DEVELOPMENT APPLICATION ASSESSMENT REPORT

Application Number:	DA2022/0469
----------------------------	-------------

Responsible Officer:	Jordan Davies
Land to be developed (Address):	Lot 11 DP 1207743, 1102 Barrenjoey Road PALM BEACH NSW 2108
Proposed Development:	Construction of shop top housing
Zoning:	B1 Neighbourhood Centre
Development Permissible:	Yes
Existing Use Rights:	No
Consent Authority:	Northern Beaches Council
Delegation Level:	NBLPP
Land and Environment Court Action:	No
Owner:	Asia Digital Investments Pty Ltd
Applicant:	Reform Projects Pty Ltd

Figure 6 - Marked up plan of level 2 showing view corridors and setbacks - Marked up by assessing officer.

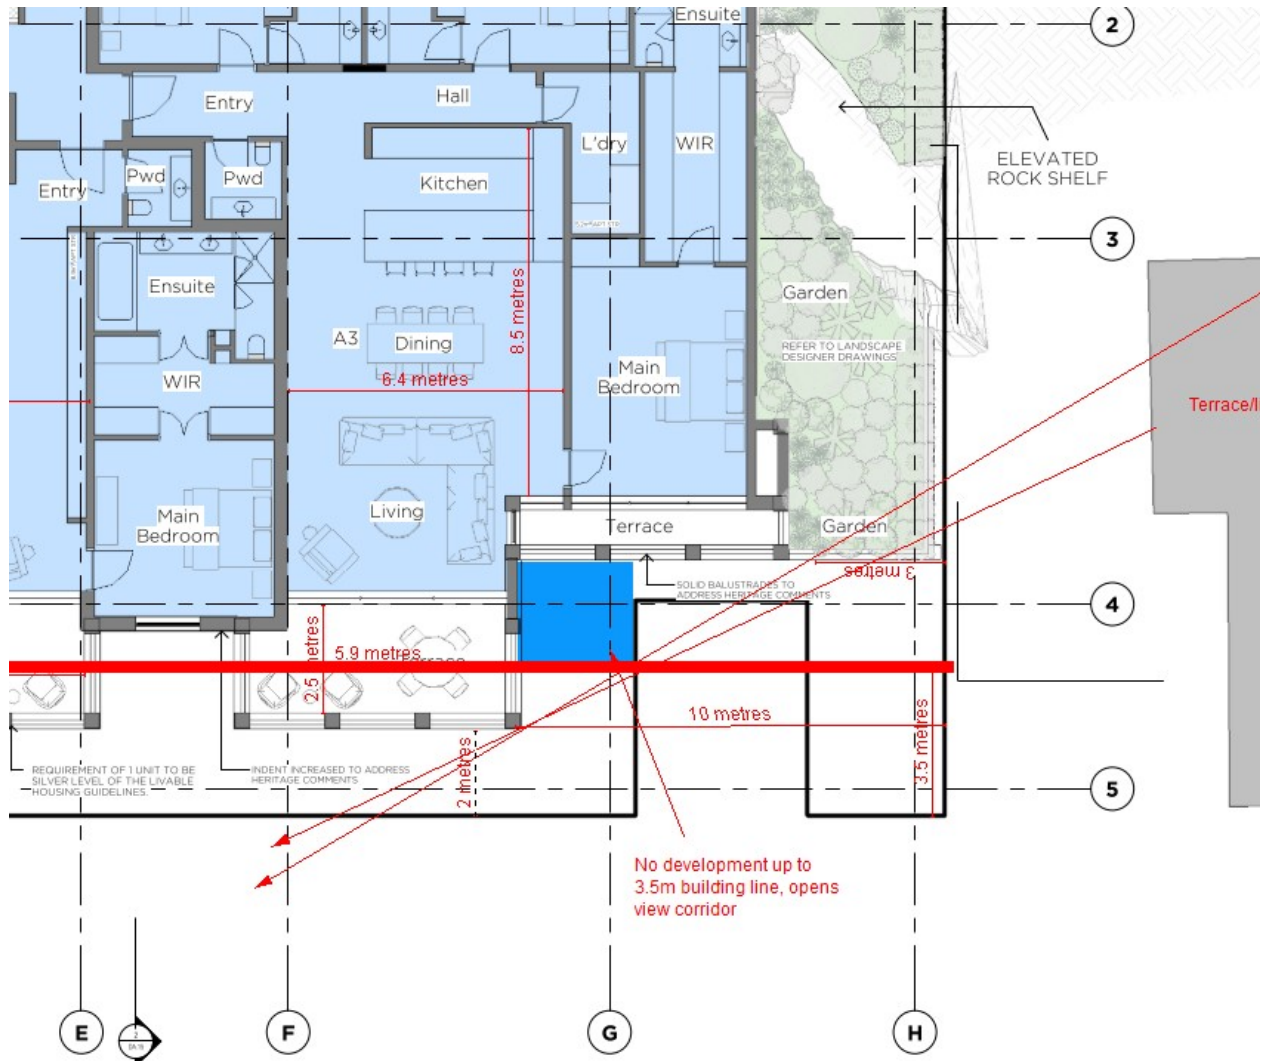
As the proposal pulls the southern corner away from the front setback (in excess of the control) the proposal has demonstrated a skillful design to minimise view impacts whilst still provide the intended architectural outcome for the development. Deleting or reducing the balcony back to 3.5m to protect filtered views from a bedroom across a side boundary is not considered a better overall planning strategy for the site and would interrupt the architectural symmetry of the façade.

Figure 1 - Extract of shadow diagram showing extent of 12pm shadow, with shadow reducing after this time

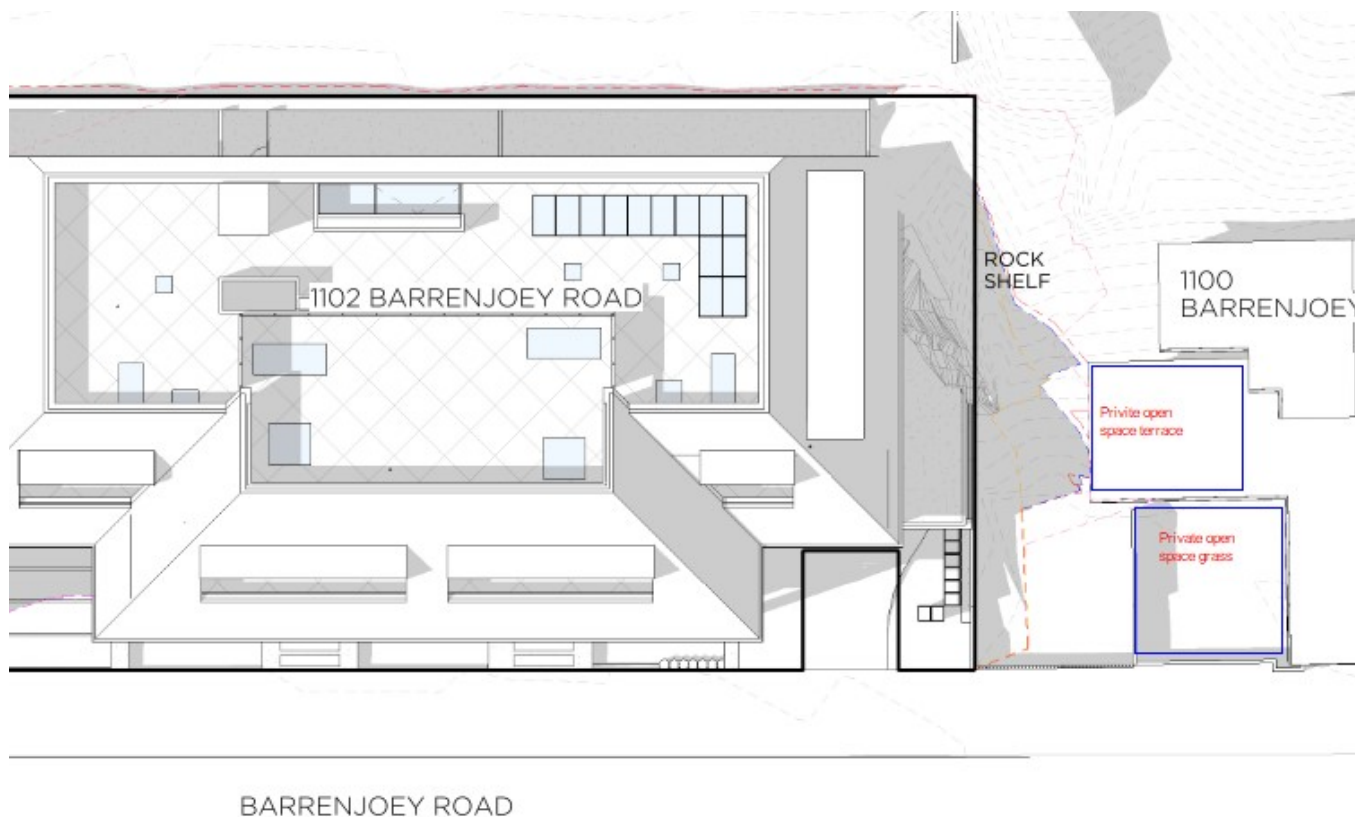
Shadow diagrams have been provided which show that there will be some overshadowing of the adjoining property prior to 12pm (which partially already occurs due to the site topography and orientation). However, following this between 12pm and 3pm (for three hours) the adjoining southern property will maintain solar access to at least 50% the living room windows and private open spaces areas consisting of a an at-grade grass area and an elevated terrace. The shadow diagrams also show the overshadowing outcome from development which is compliant with the 8.5m building height control across the building footprint (i.e an 8.5m height stepping up with the site topography). The comparison shows that the solar access outcome between the two scenarios is not materially different and at 12pm, is a better outcome than a 8.5m building height spread across the site. Notwithstanding this comparison, the adjoining property will maintain solar access in accordance with the controls.
